Access Compliance Report

Public Rights-of-Way

Intersection ID: N/A	Main Street: BLAKENEY PROFESSIONAL DR	Cross Street: BISHOP CREST LN	Location: SW
ADA ID: A58467D0BC22	Ramp Type: BlendTrans2	Initial Pass/Fail: Fail	Overall Compliance: No
Severity Score: 10			
Codes/Mitigation Info/Possible Solution		Field Measurements/Component Compliance

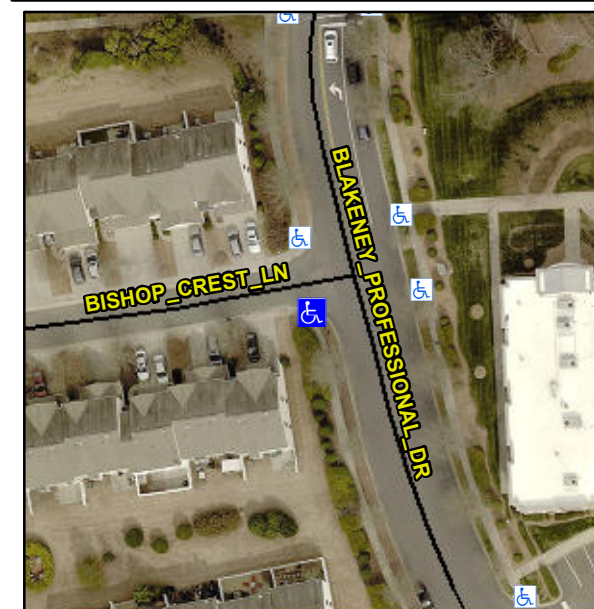
R304.5.1, R304.5.3

Compliance	Description	Data	Compliance	Description	Data
N/A	Ramp Length (in)	132.0	Yes	BlendTrans Slope (%)	3.7
No	Ramp Width (in)	46.0	No	BlendTrans XSlope (%)	2.7
N/A	Flare Type LT	N/A	N/A	Flare Type RT	N/A
N/A	Flare Slope LT (%)	N/A	N/A	Flare Slope RT (%)	N/A
N/A	Flare Traversable LT?	N/A	N/A	Flare Traversable RT?	N/A
N/A	Landing Length (in)	N/A	N/A	DWS Provided?	N/A
N/A	Landing Width (in)	N/A	N/A	DWS Contrast?	N/A
N/A	Landing Slope (%)	N/A	N/A	DWS Length (in)	N/A
N/A	Landing X Slope (%)	N/A	N/A	DWS Full Width?	N/A
N/A	Landing Curb? (Y/N)	N/A	N/A	DWS Offset (in)	N/A
N/A	Shared Landing?	N/A			
N/A	Gutter Ponding?	N/A	N/A	Gutter Slope (%)	N/A
N/A	Gutter Lip Ht (in)	N/A	N/A	Gutter X Slope (%)	N/A
N/A	Painted X Walk1?	No	N/A	Painted X Walk2?	No
	X Walk 1 Direction	To E		X Walk 2 Direction	To N
	X Walk 1 Width (in)	N/A		X Walk 2 Width (in)	N/A
	X Walk 1 Slope (%)	0.2		X Walk 2 Slope (%)	1.3
	X Walk 1 X Slope (%)	0.6		X Walk 2 X Slope (%)	0.9

Remove & Replace Curb Ramp With Two New Directional Ramps or Equivalent.
